TB1106

SERVICE INFO

LuK Part Nr. 230 0017 11 - TGU6 280/280mm

Mercedes MB-Track**

New design / Neues Design / Nouvelle conception / Nuevo diseño / Nuovo disegno

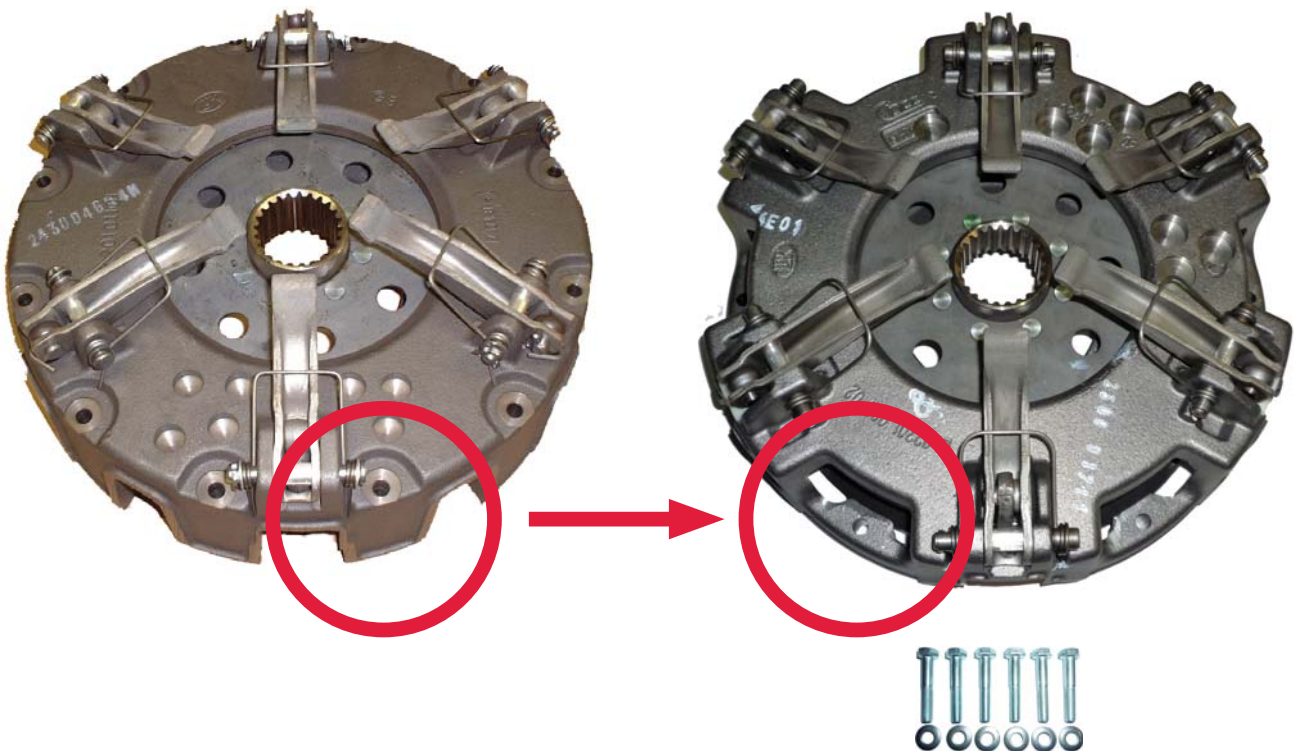
This new design utilises the latest clutch technology, using a vented housing for improved cooling and heat dispersal.

Early 12 bolt design clutch 230 0017 11 was fitted to 8 bolt fixation flywheel.

New design clutch using 6 bolt fixation requires a **new flywheel** [Mercedes ref: A 314 030 39 05] with 12 fixation holes.

A new fixation bolt set **6 x M8 x 1.25 x 50mm** is supplied with new designs to accommodate the lower housing.
